UTILITY ANALYSIS
FLOW TEST

RE: Northeast Metrotech Regional High School
Flow Test and Pump Systems Verification

Project #: 60-20-409

HYDRANT FLOW TEST SUMMARY SHEET

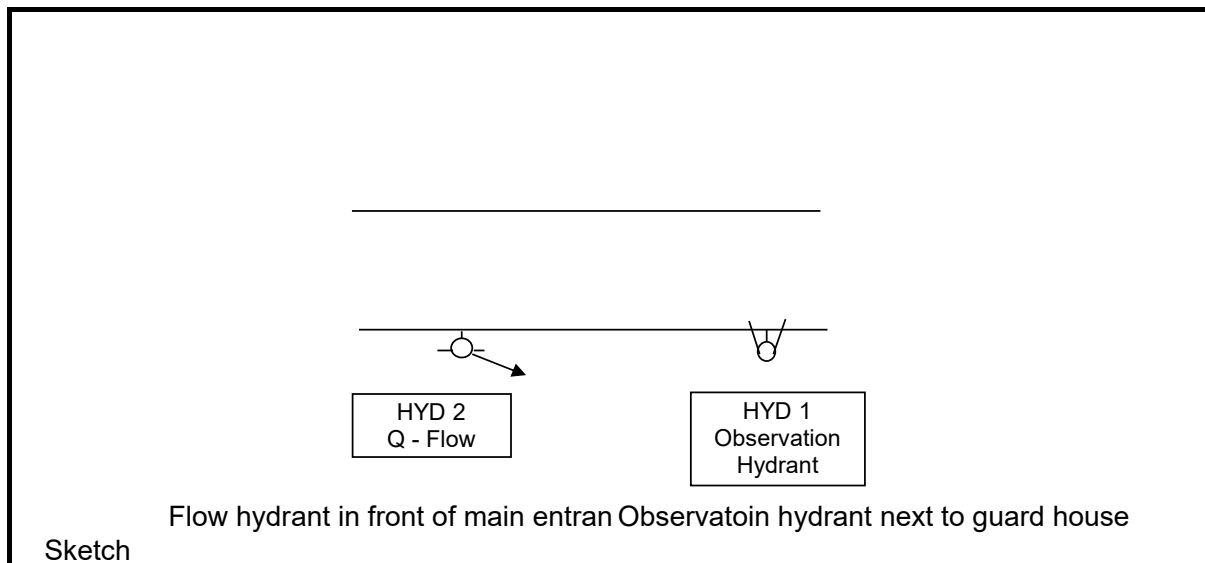
We have reviewed the flow tests conducted on 6/24/2021 and based on this review we have determined that they are consistent as far as the flow test from Old Nahant (Observation Hydrant at elevation approximately 133.0' per Google Earth) should be from a better looped main versus the flow test from the existing High School (Observation Hydrant at elevation approximately 88.0' per Google Earth) would be from a dead end line or not so well looped main. This is noted on the basis that the flow test from the existing High School site has a lower residual pressure. Per these (2) test results, the projected values at our building site are at elevation 163.50' for the new building.

1. A fire pump will be required for the main building.
2. A domestic booster will be required for the main building.
3. A water tank will not be required for the main building. The addition of the feed main currently planned originating from Old Nahant is essential as far as making the system work.
4. Booster pumps will not be required for the satellite building based on their elevations per information from the Landscape drawings.
